<b>Topic: Public consultation, TEK and Community-Based monitoring</b>		
<b>Q #</b>	<b>Question</b>	<b>Response</b>
1	Please provide exact details of various discussions and meetings held with local communities and how the resolution of the concerns and issues was incorporated into project development impact mitigation and proposed monitoring.	<ul style="list-style-type: none"> <li>• Since the announcement of the JPME and PRM projects, Shell has met regularly with the MCFN and other First Nations to identify potential impacts, issues and concerns. The following types of meetings have been held: open houses, quarterly GIR meetings, Advisory Committee meetings, technical review meetings and reports, NNLP meetings, site visits, etc.</li> <li>• All of these formal meetings have notes that are sent out in Draft for review by stakeholders and then finalized. MCFN will have copies of all of these detailed notes. A summary of these meetings and discussions is provided in the bi-monthly reports provided to both MCFN and AENV.</li> <li>• These forums have been used to identify issues and concerns of the MCFN and other aboriginal stakeholders. Examples of this include; the opportunity to discu

**AQ01:  
 Fish Tissue Samples**

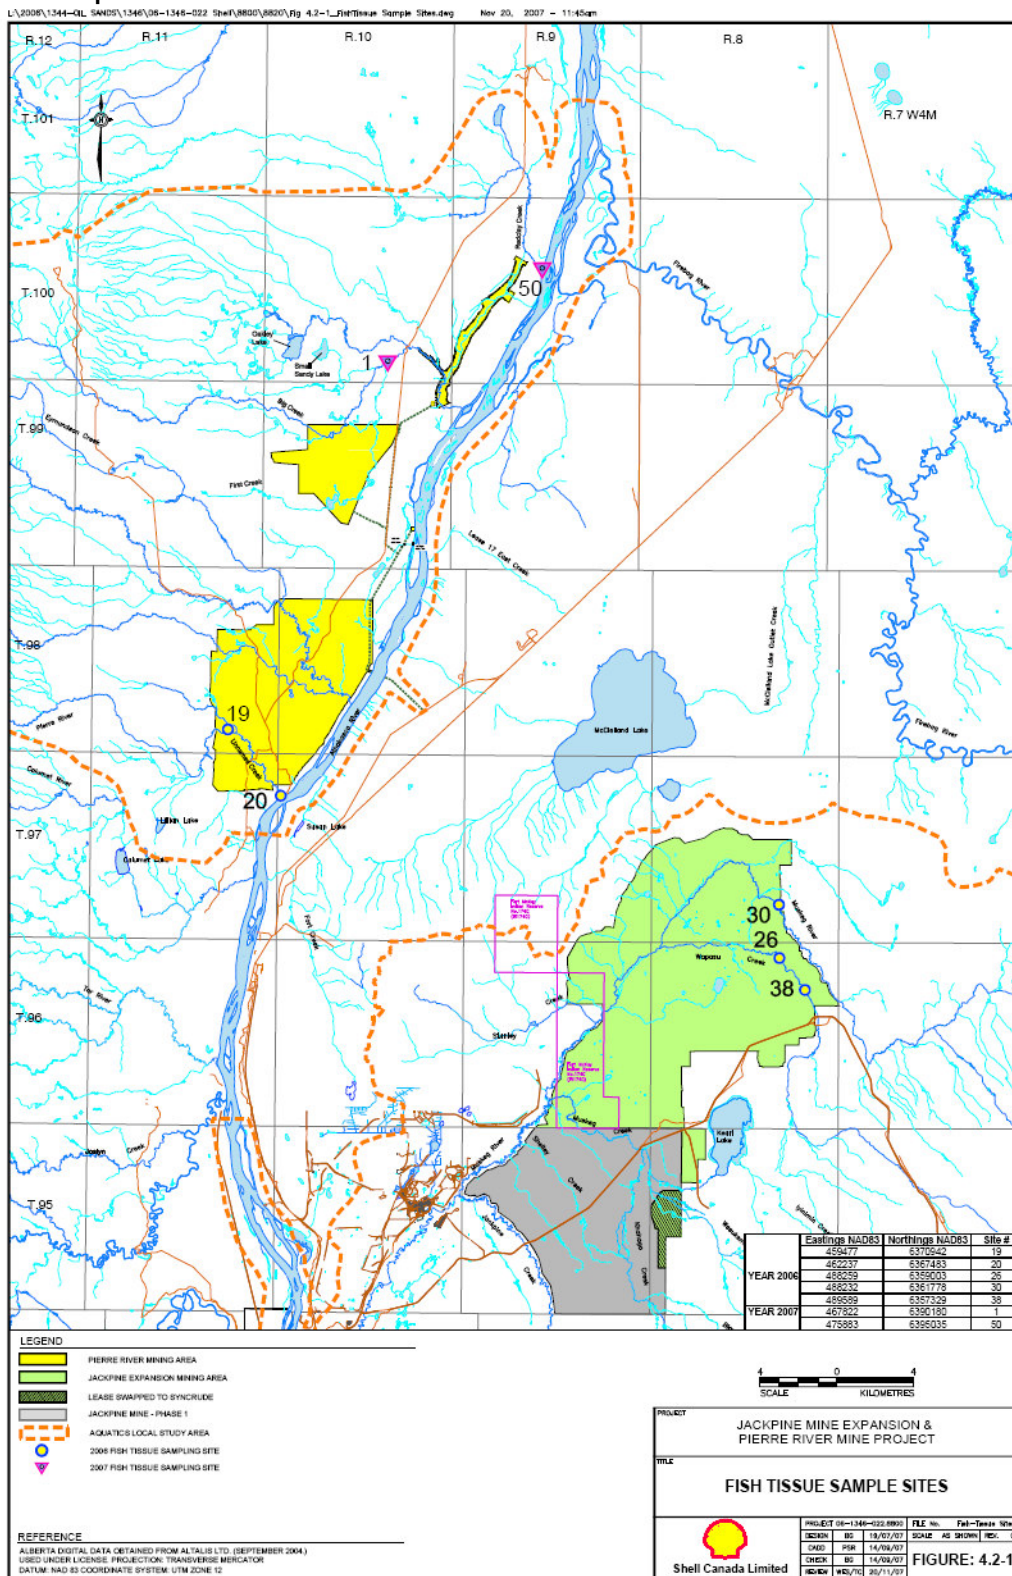
Aquatic Health		
Q #	Question	Response
1	<p>We recommend requesting an increase in sample size, which would strengthen the rigour of analyses performed on individual parameters. Tissue sampling and analysis are expensive to do; however, compromising sample size can put ecosystem health at risk for aquatic life and humans. At least 30 samples need to be collected of individual parameters to achieve statistical significance.</p>	<ul style="list-style-type: none"> <li>• Seven species sampled with a total of 32 fish from the aquatic study area.</li> <li>• Obtained screening level spatial and taxonomic coverage.</li> <li>• Data appropriate for EIA-level of analysis.</li> </ul> <p>Fish collected from ASA used for the aquatic health assessment; locations are provided in parentheses where appropriate</p> <ul style="list-style-type: none"> <li>• Total of 8 fish for JME:                             <ul style="list-style-type: none"> <li>• 2 samples of white sucker (26,38)</li> <li>• 1 composite sample (19, 20, 30, 38)</li> <li>• 5 Northern Pike from the RAMP program (Muskeg River)</li> </ul> </li> <li>• Total of 4 fish for PRM:                             <ul style="list-style-type: none"> <li>• 1 Lake chub, 1 slimy sculpin (1)</li> <li>• 2 long nosed sucker (50, 19)</li> </ul> </li> <li>• 20 fish from the Athabasca River (RAMP):                             <ul style="list-style-type: none"> <li>• 10 walleye and 10 whitefish</li> </ul> </li> </ul> <p>Figure showing fish tissue sample sites is located at end of the Aquatic Health section in this document.</p>

Athabasca Valley WBEA Station

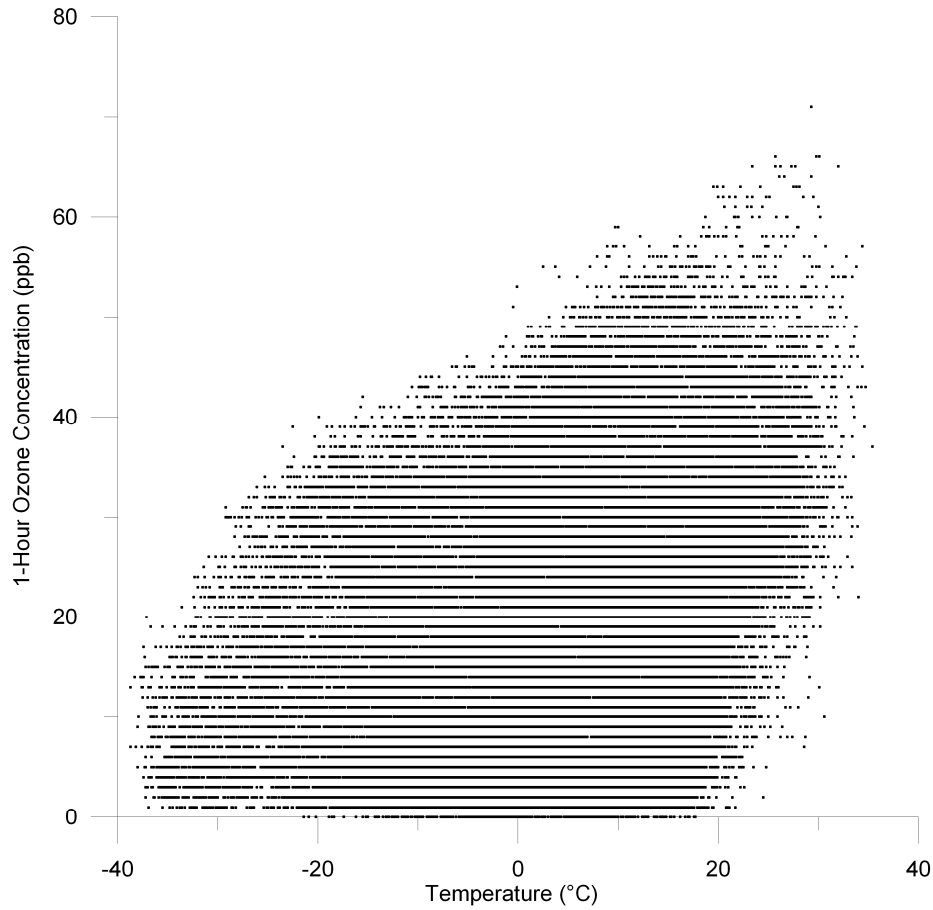
11	<p>Did the maximums of daily temperature and ozone occur on the same hour? Is a fair comparison being drawn? What does this look like when comparing the maximum ozone with corresponding temperature, and maximum temperature with corresponding ozone?</p>	<ul style="list-style-type: none"> <li>• Purpose of graph was to show relationship between temperature and ozone.</li> <li>• The maximum daily temperature and maximum daily ozone concentration did not always occur at the same hour.</li> <li>• Following figure shows hourly temperature plotted with hourly ozone for Athabasca Valley WBEA station.</li> <li>• The same general pattern is shown (i.e., peak hourly ozone does not always correspond to the highest temperatures).</li> </ul> <p>See Figure of Athabasca Valley WBEA Station at the end of the Air Quality section in this document.</p>
